ADDENDUM NUMBER 8

- 1.01 DATE: APRIL 13, 2021
- 1.02 PROJECT: WELCOME CENTER
- 1.03 PROJECT NUMBER: DCM NO. 2020604
- 1.04 OWNER: ALABAMA A&M UNIVERSITY
- 1.05 ARCHITECT: NOLA | VAN PEURSEM ARCHITECTS, PC

SHEET TITLE
FIRST FLOOR PLAN

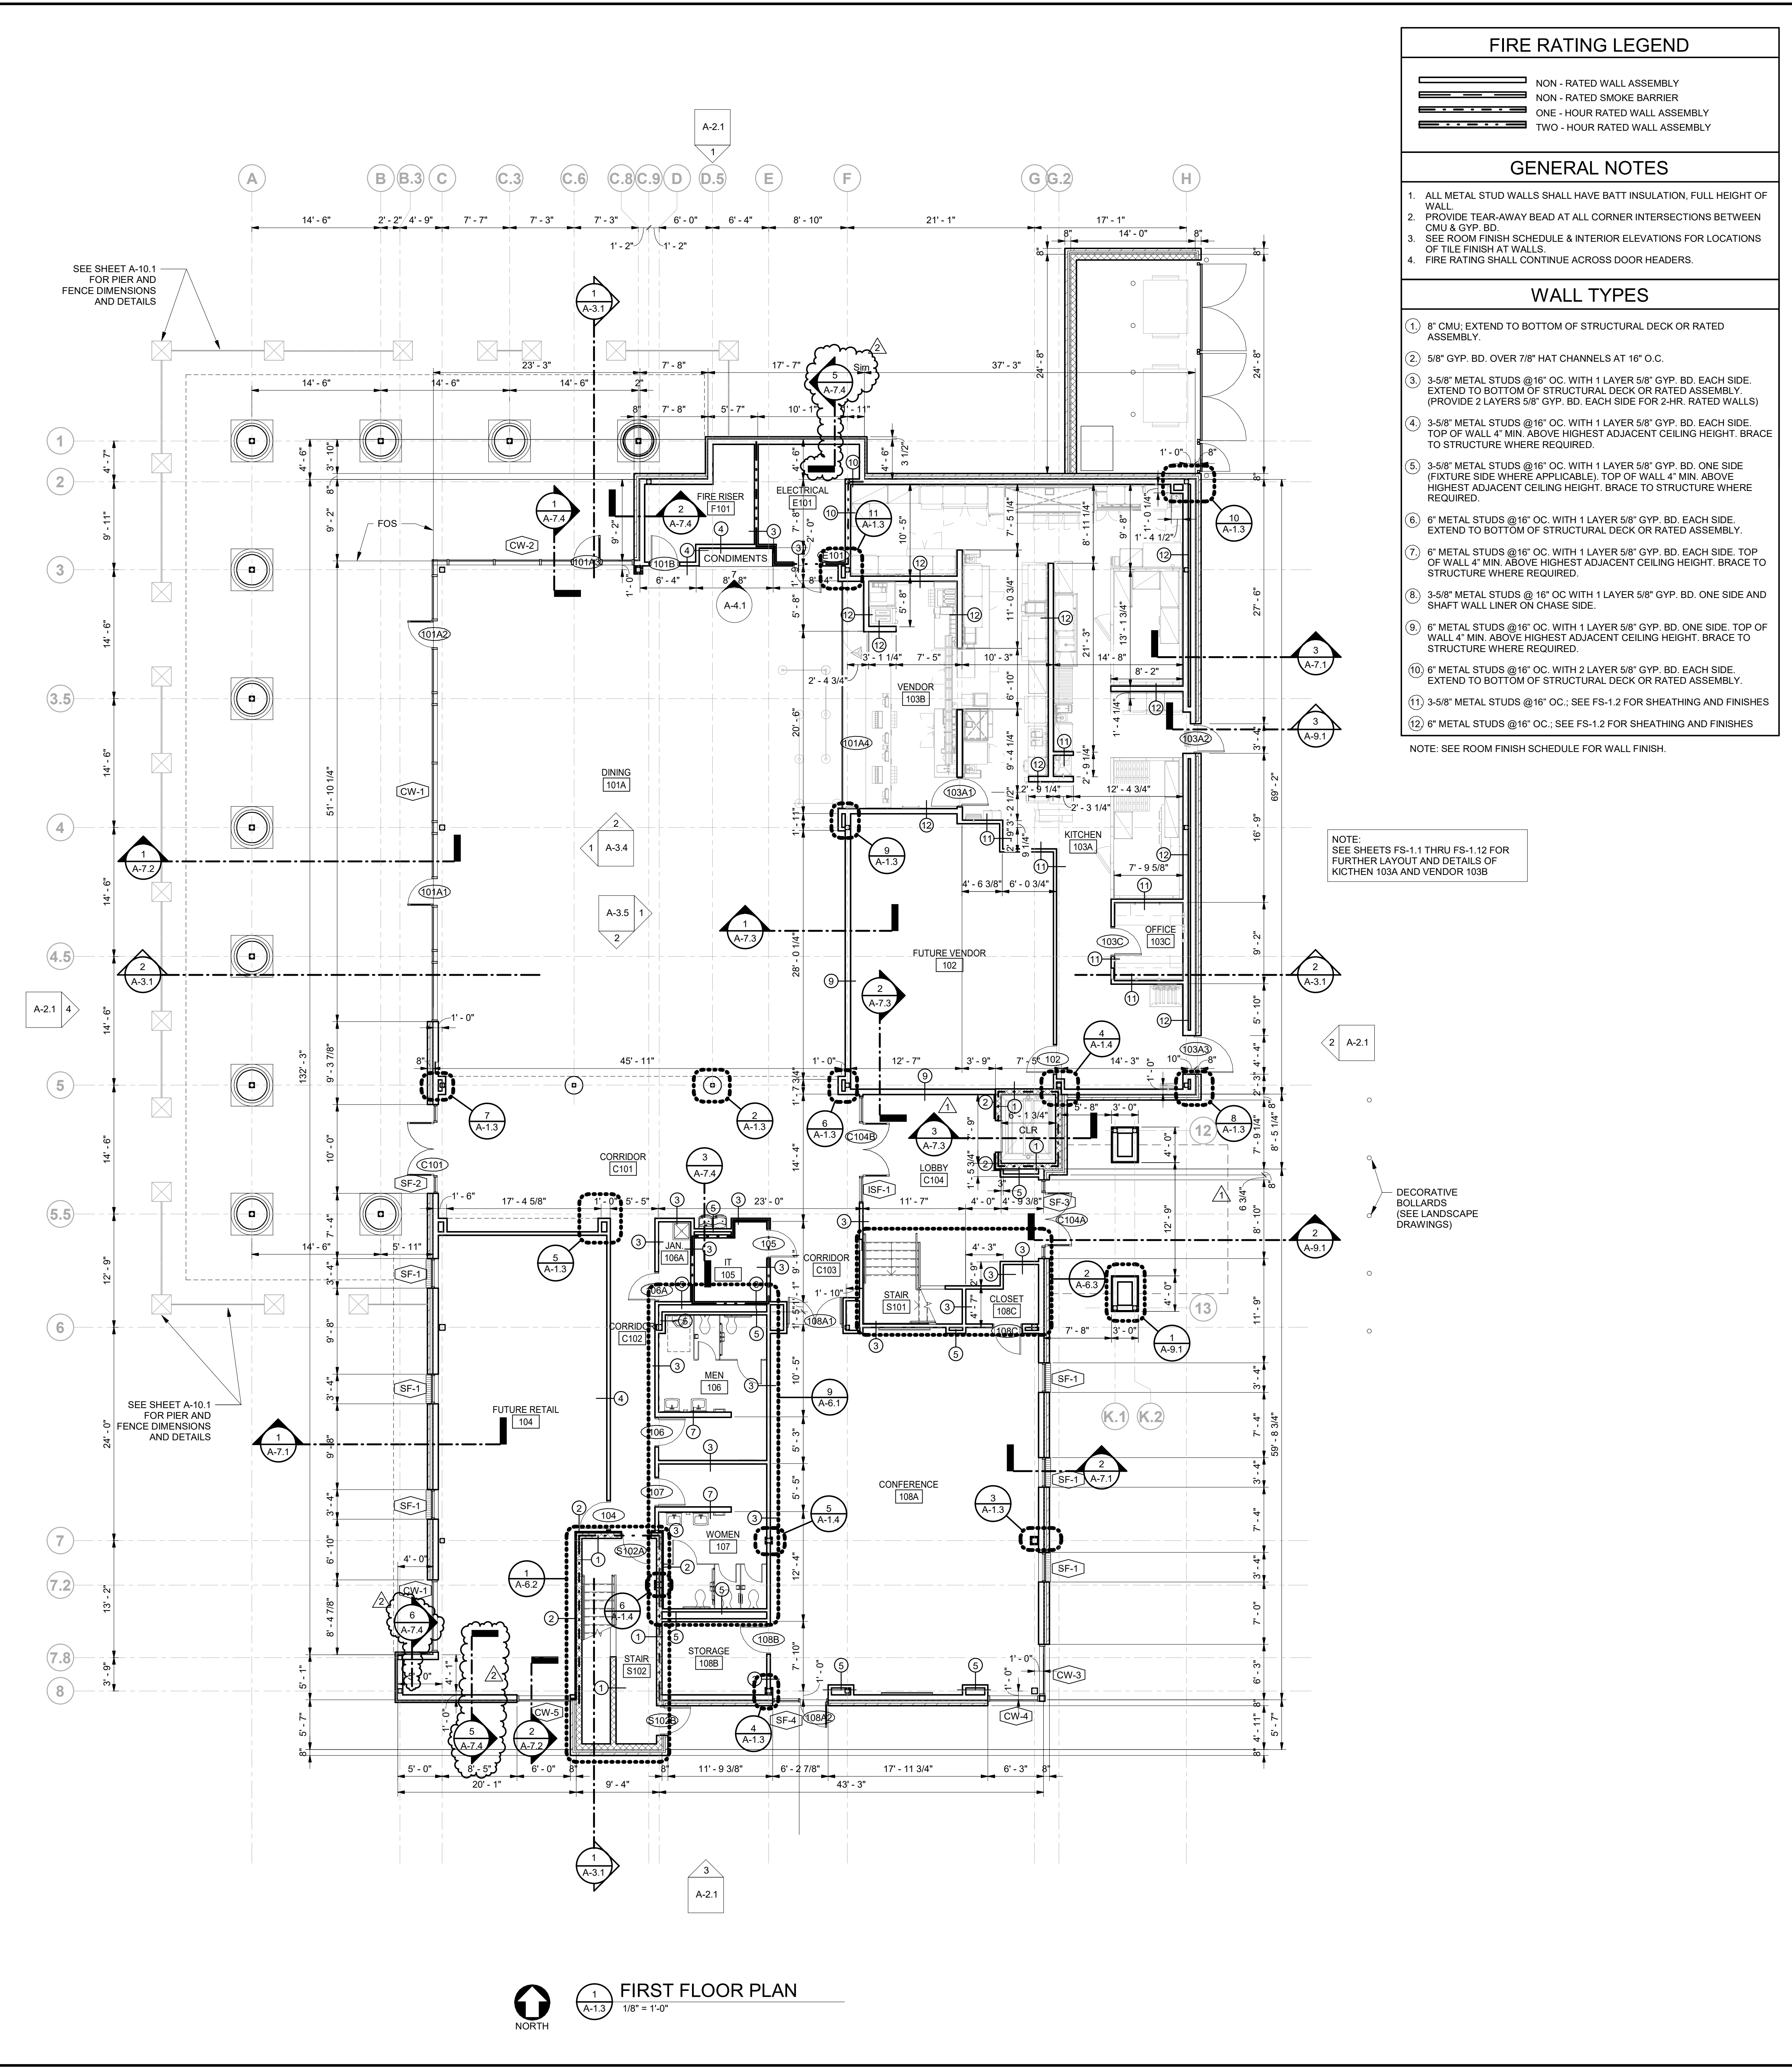
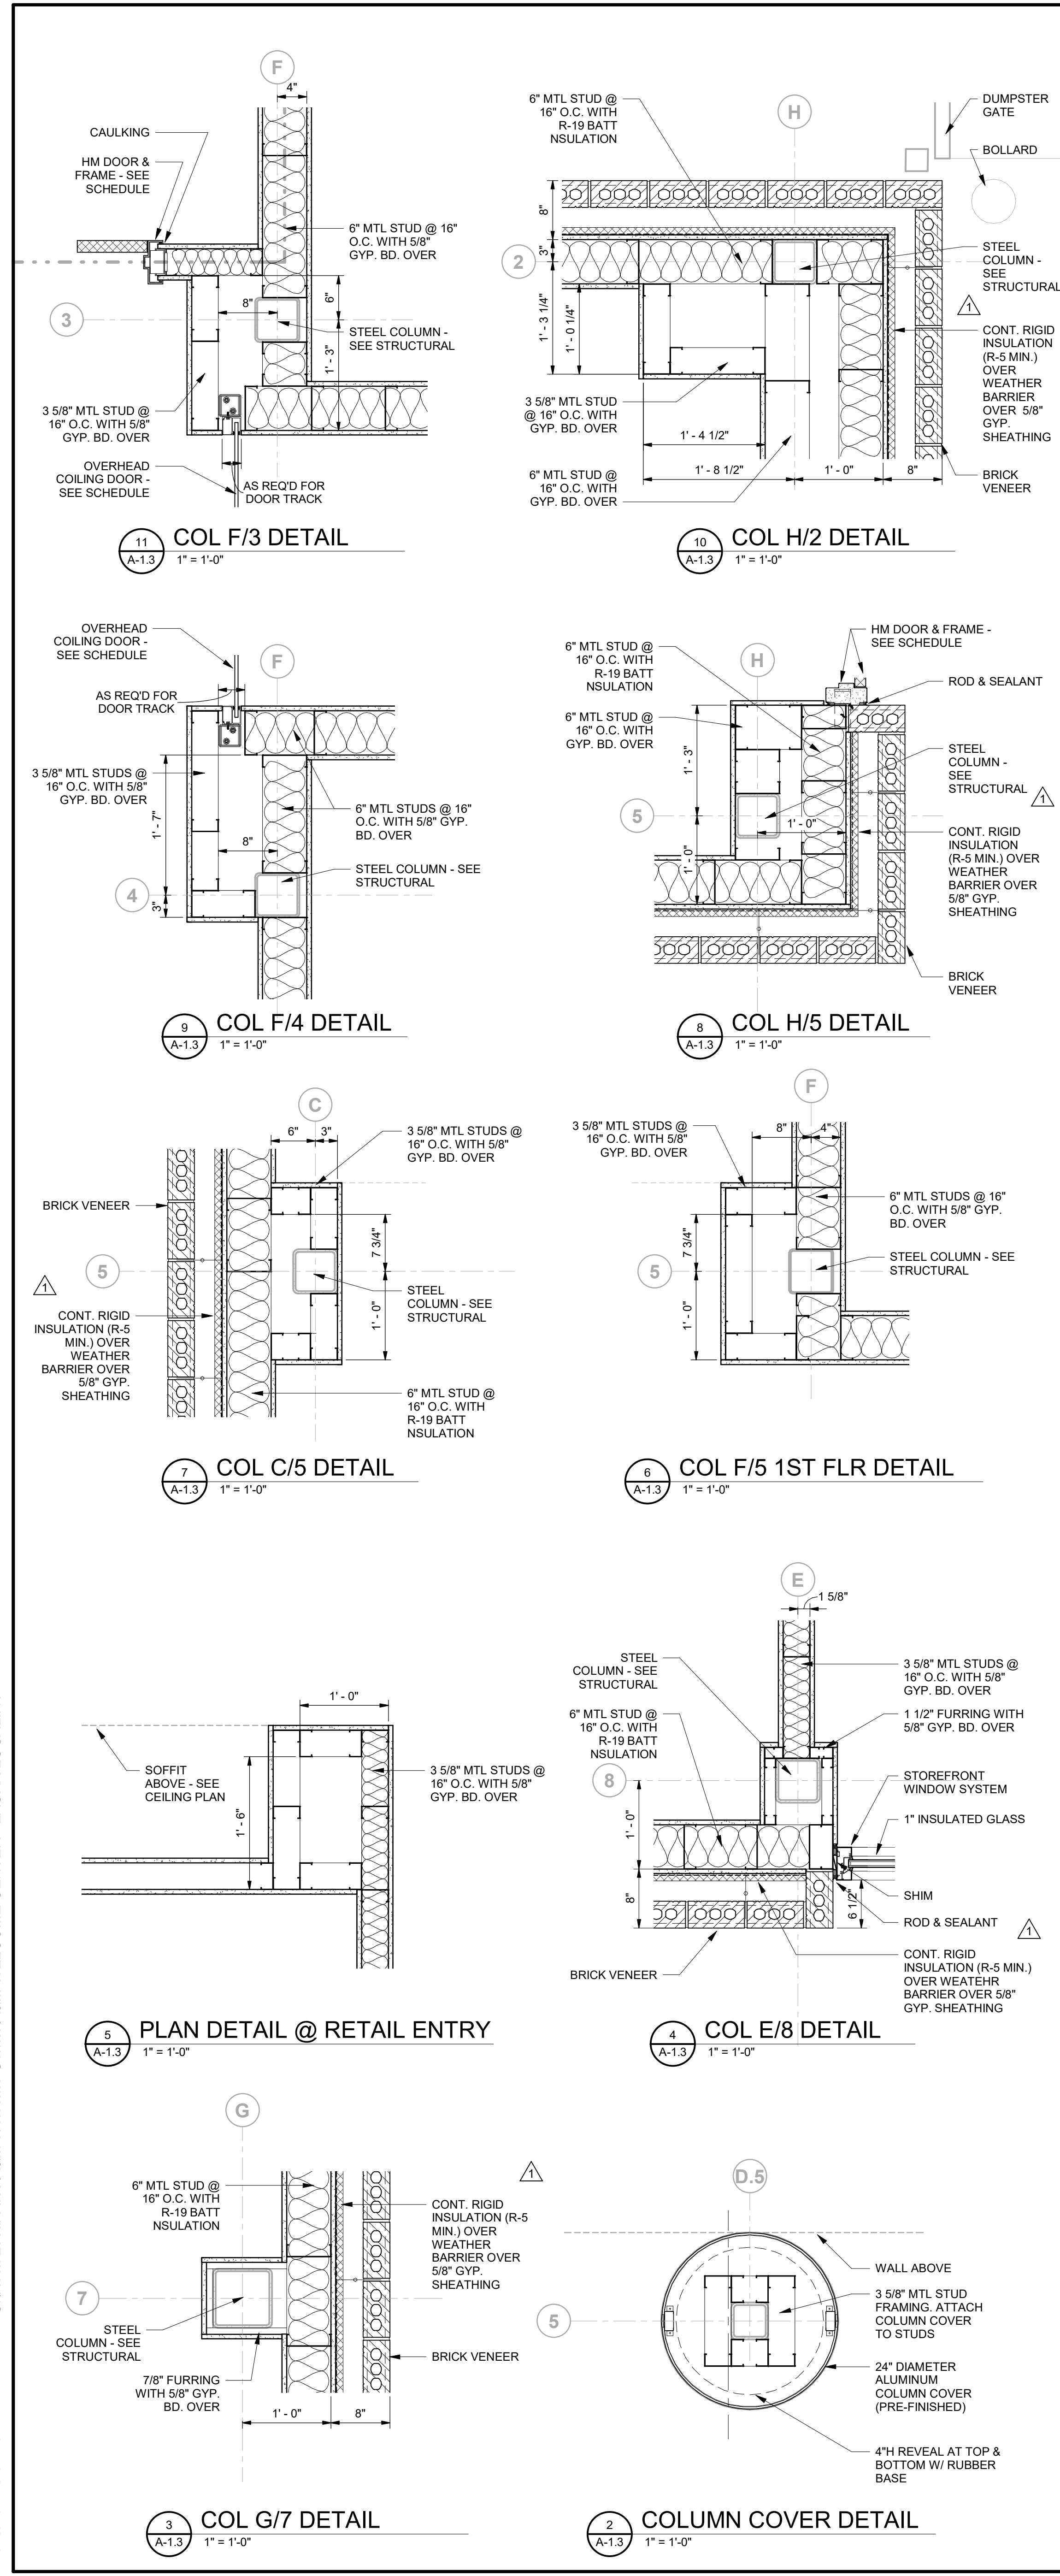
4.01 SHEET A-1.3 – FIRST FLOOR PLAN:

A. Replace this sheet in its entirety. Revisions include the following: Added wall section marks.
